# PLANNING AND ZONING CASE CHECKLIST

P&Z CASE # SP2020-017 P&Z DATE 08/11/20 CC DATE 08/18/20 APPROVED/DENIED  
ARCHITECTURAL REVIEW BOARD DATE \_\_\_\_\_ HPAB DATE \_\_\_\_\_ PARK BOARD DATE \_\_\_\_\_

07/24/2020: SP2020-017; Site Plan for 407 W. Washington Street

- I.1 This is a request for the approval of a Site Plan or an office building on a 0.28-acre parcel of land identified as Lot 2-R, Block A, Washington Place Addition, City of Rockwall, Rockwall County, Texas, zoned Downtown (DT) District, addressed as 407 W. Washington Street.

A1.0

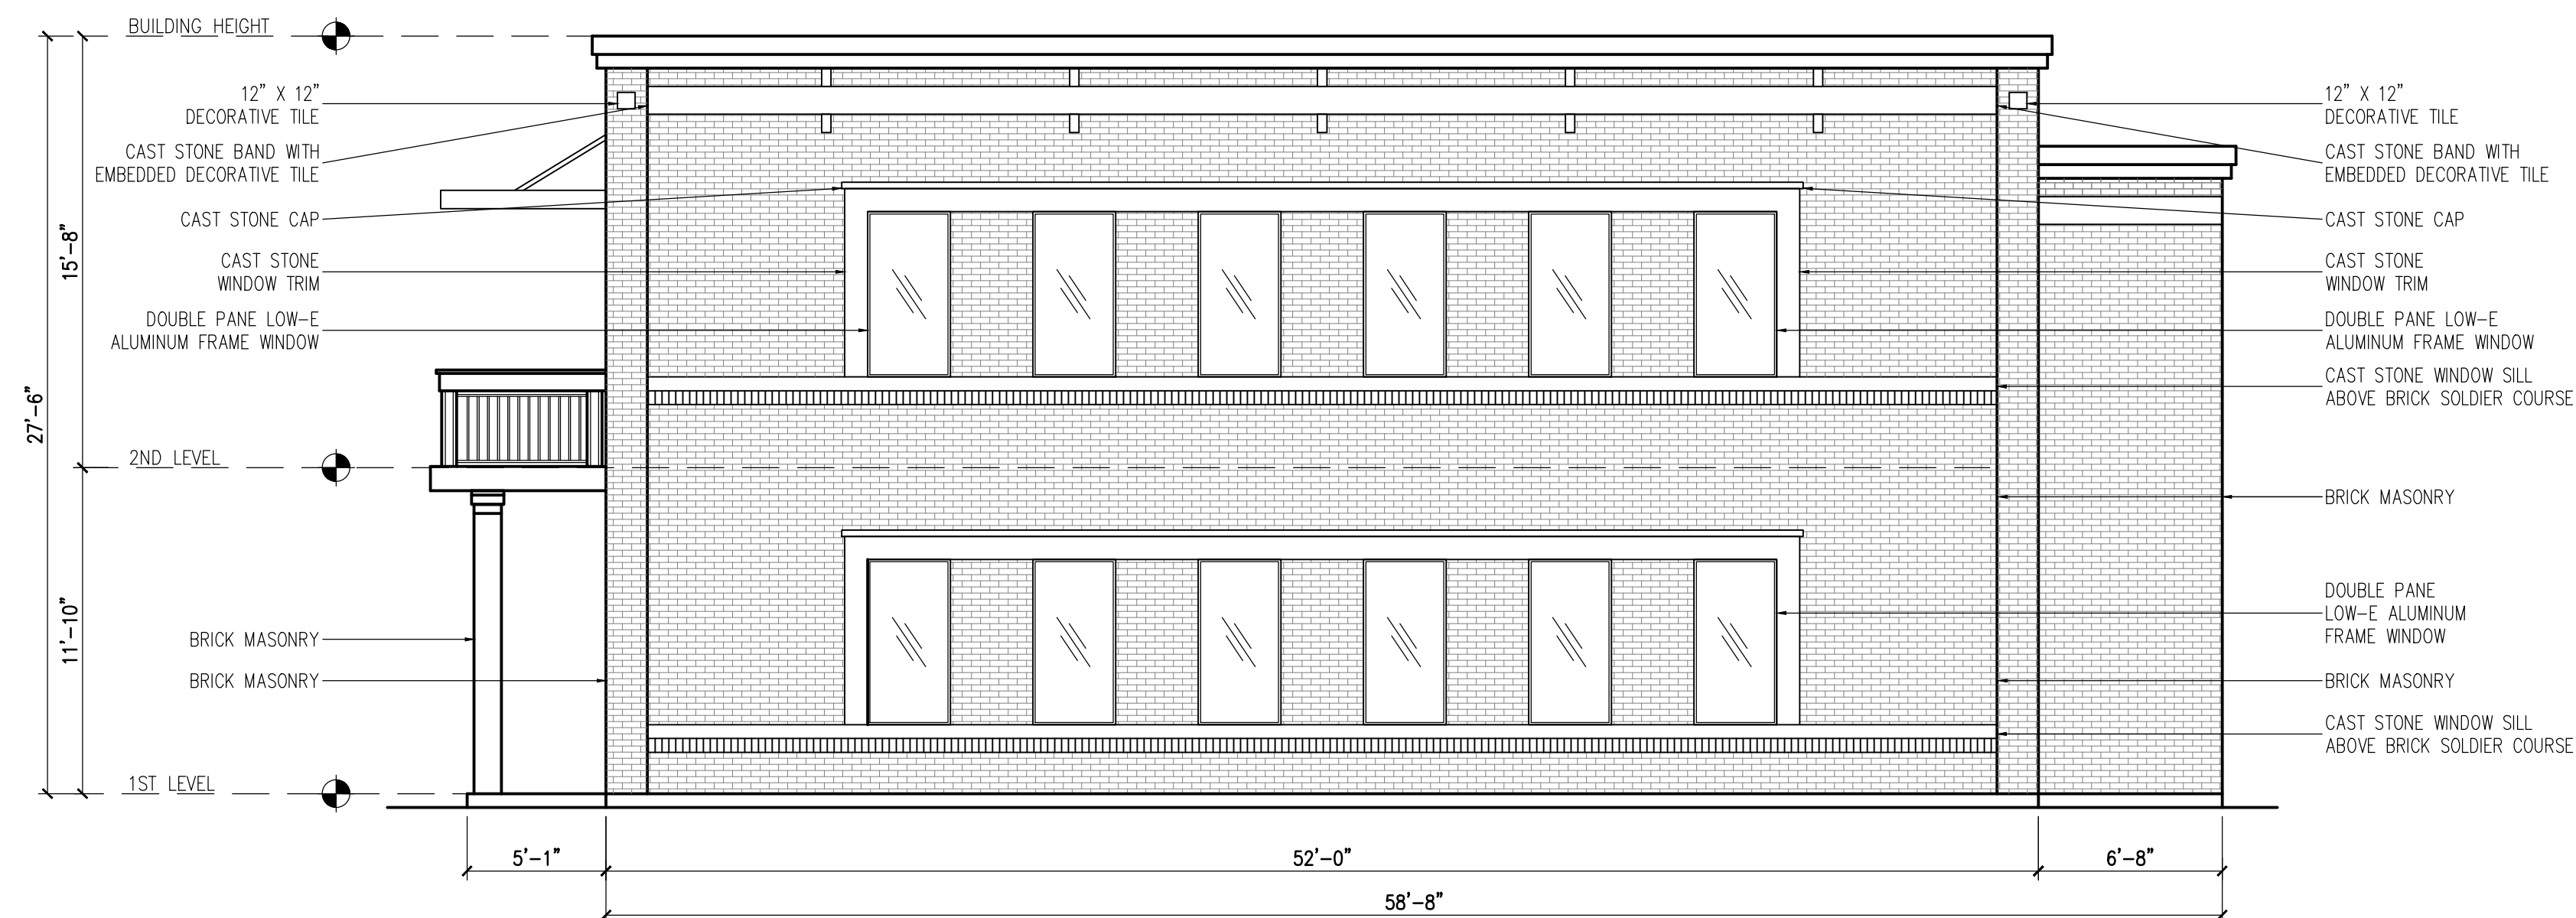
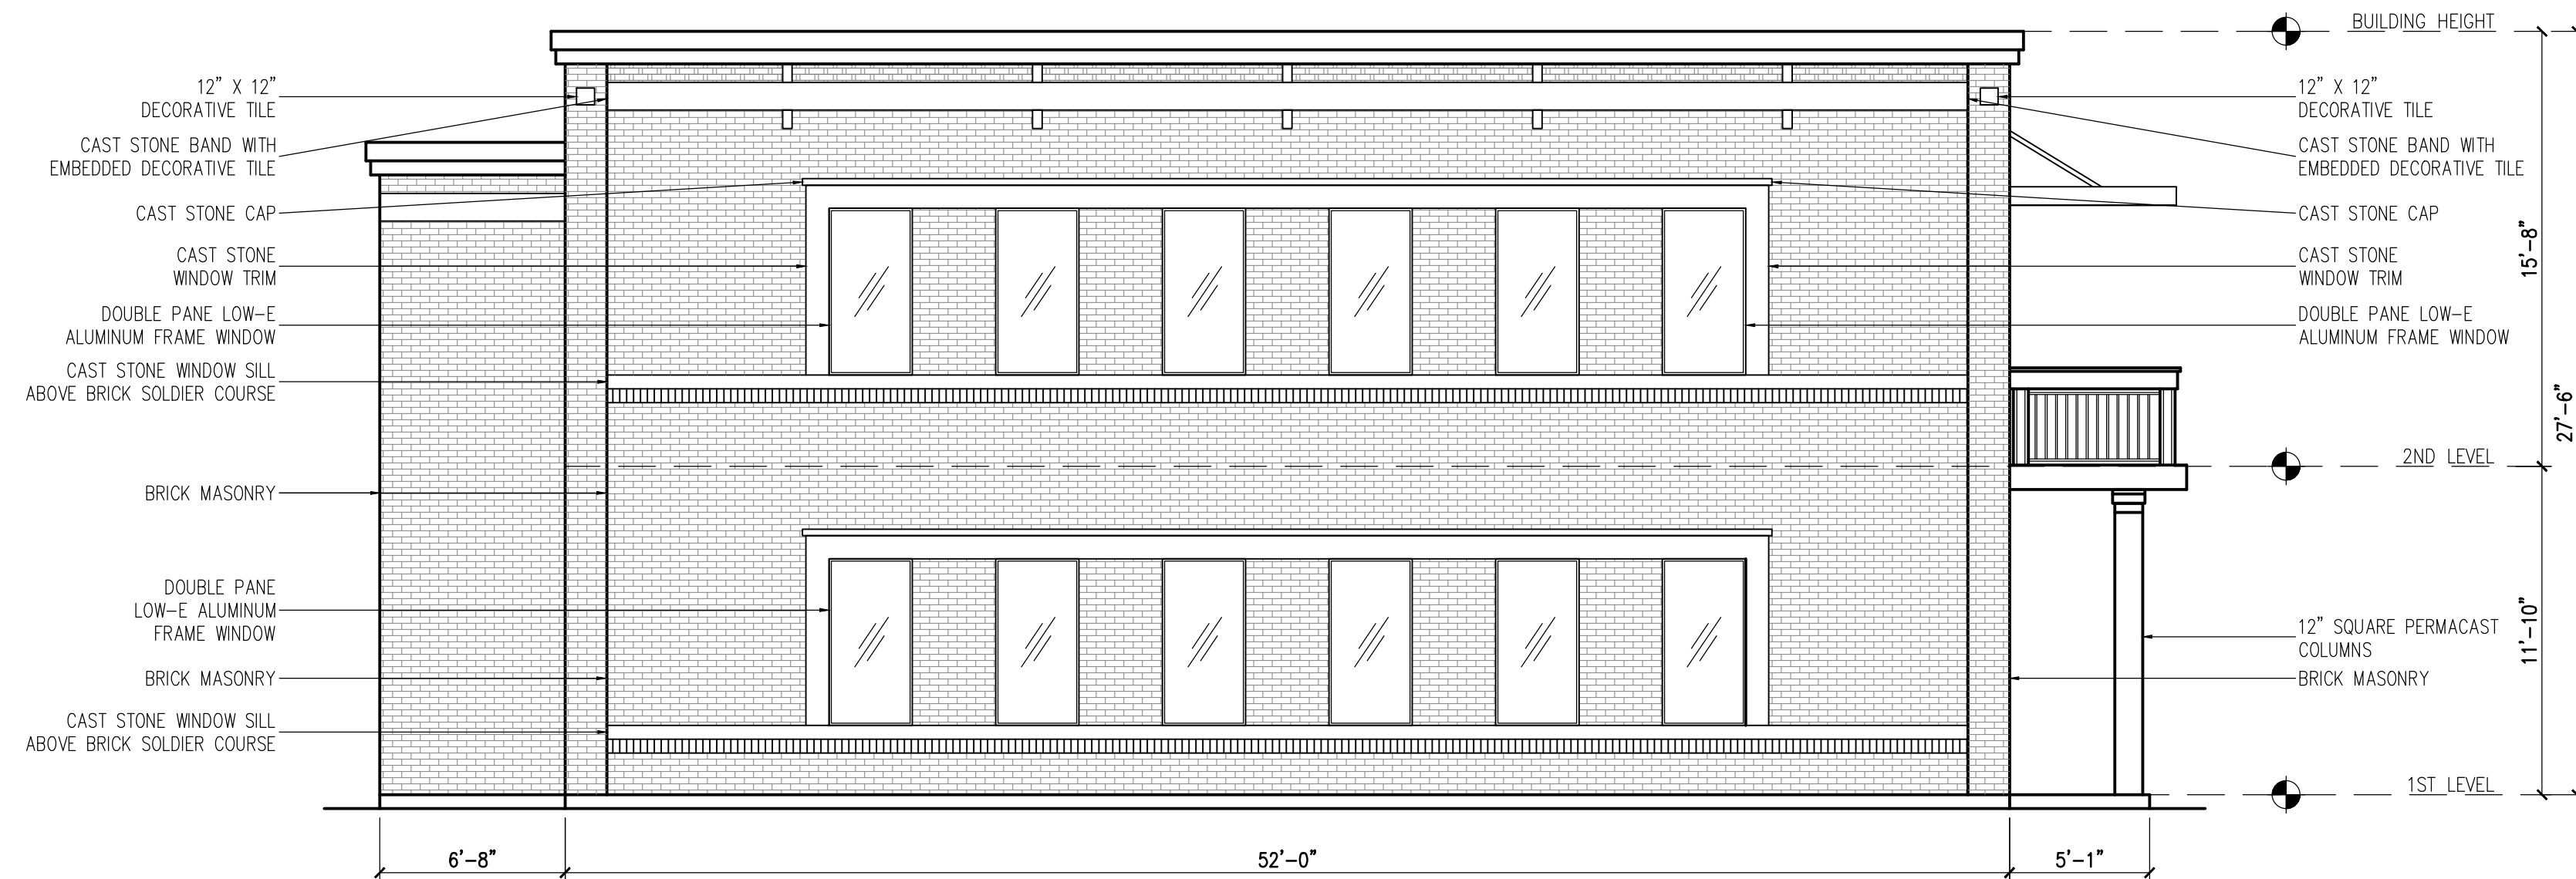
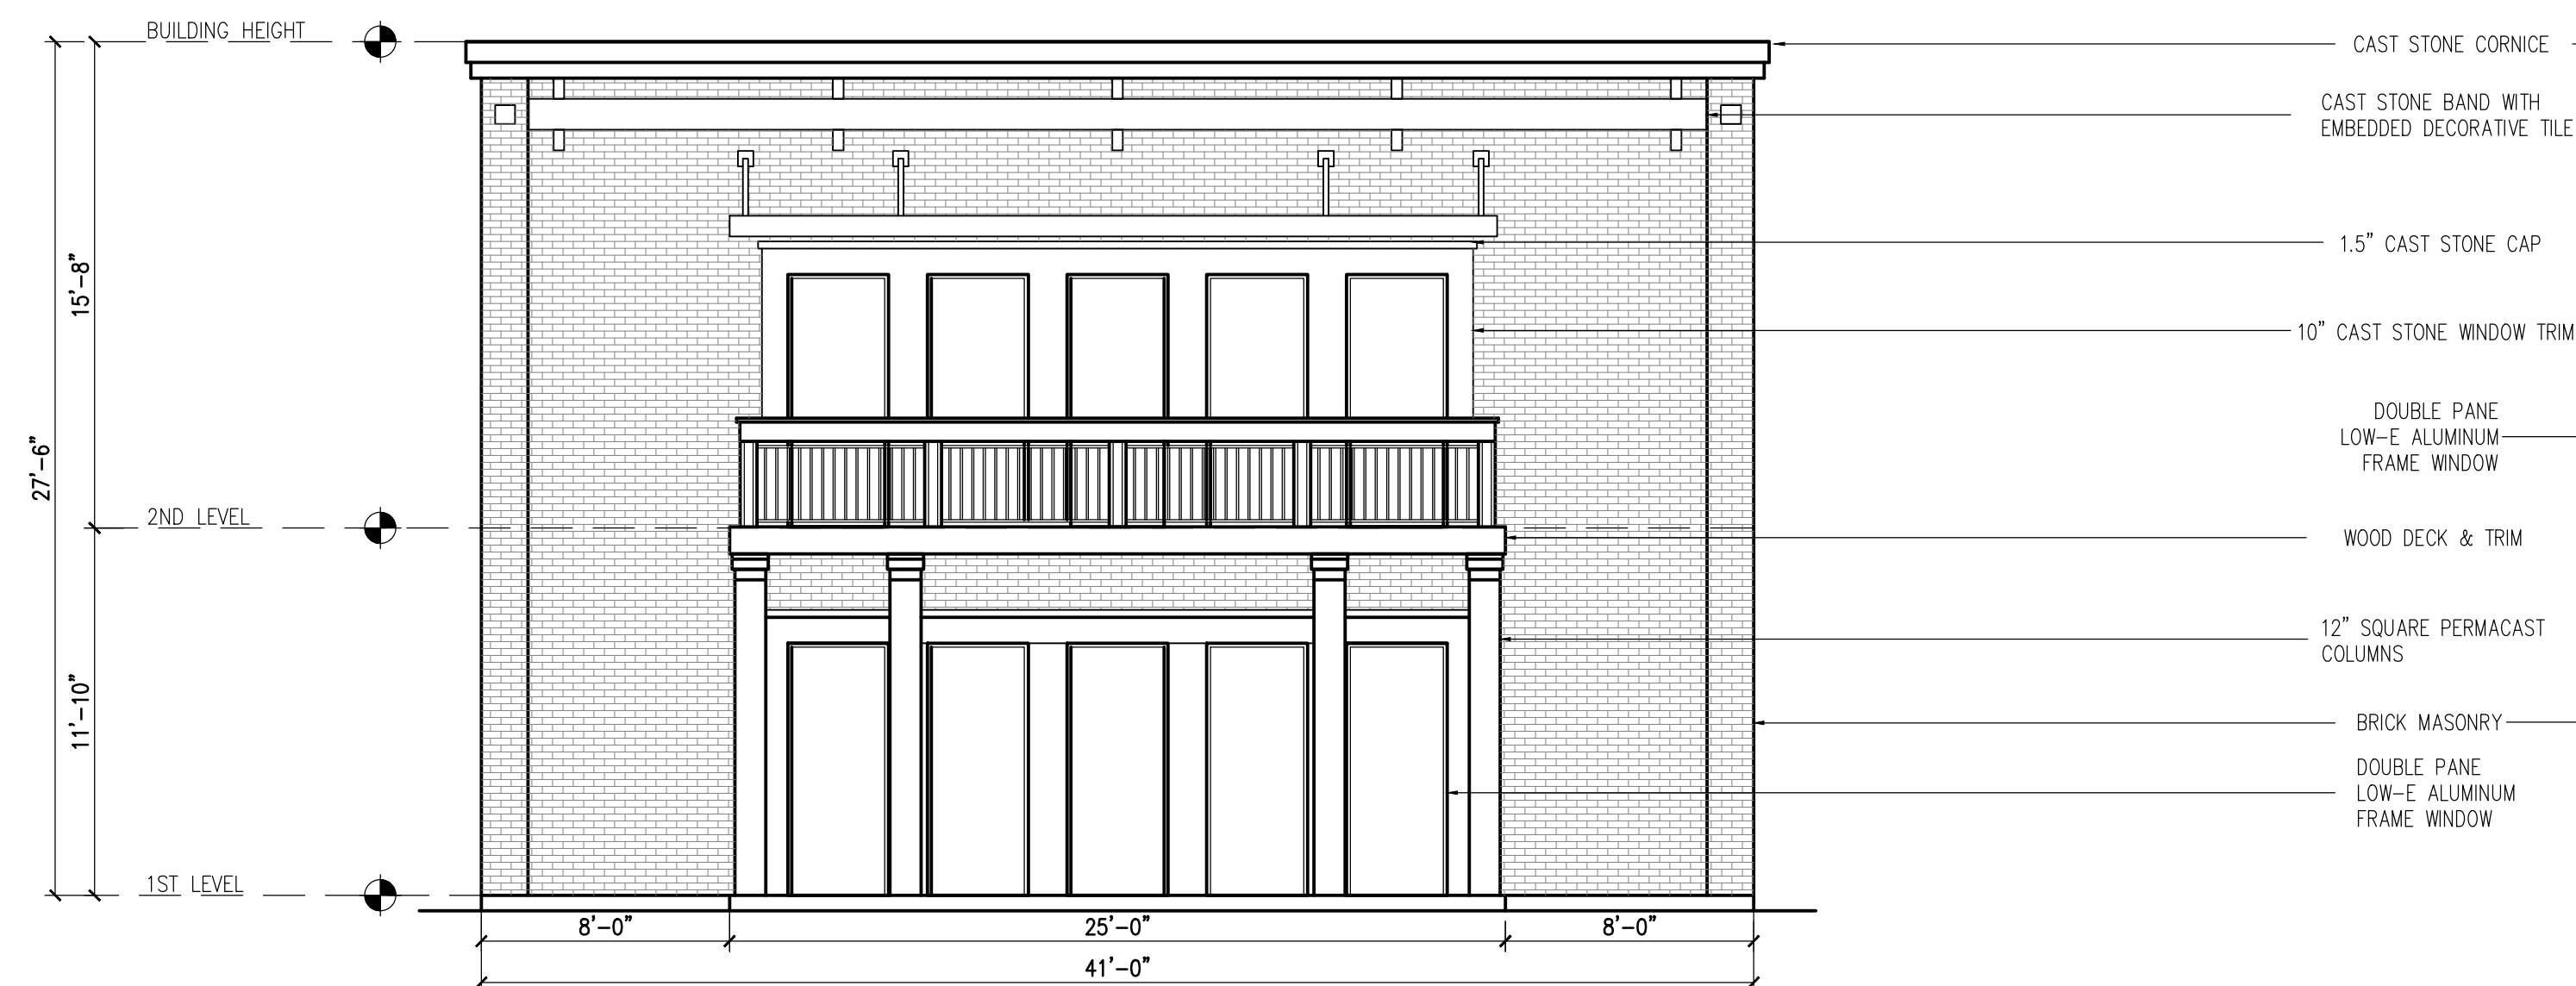
- 1) Indicate all RTU units on the building elevations (i.e. dash-in) so that staff can ensure that they meet the screening requirements. (§06.02.C.3.a, Art. 05, UDC)
- 2) Projecting elements and parapets that are visible from adjacent properties or public right-of-way shall be finished on the interior side using the same materials as the exterior facing wall. Provide a finish for the TPO roof that matches the exterior. (§04.01.A.1, Art. 05, UDC)
- 3) The columns indicated on the building elevations (i.e. north) do not indicate the type of materials being used. Are these brick columns as indicated on the color rendering. If not, consider using the brick columns. (Informational comment).

- 2) Architectural Features. The proposed building requires approval of waivers to the following features:
  - a. Windows shall have at least a four (4) inch reveal and except for retail at grade, shall be vertical in proportion. Provide detail of 4" reveal. Minor Waiver. (§04.07.D(2)(b)(2), Art. 05, UDC)

Plans shall reflect the required 1-hr fire rating for the east exterior wall and protected openings (windows) in accordance with the International Building Code.
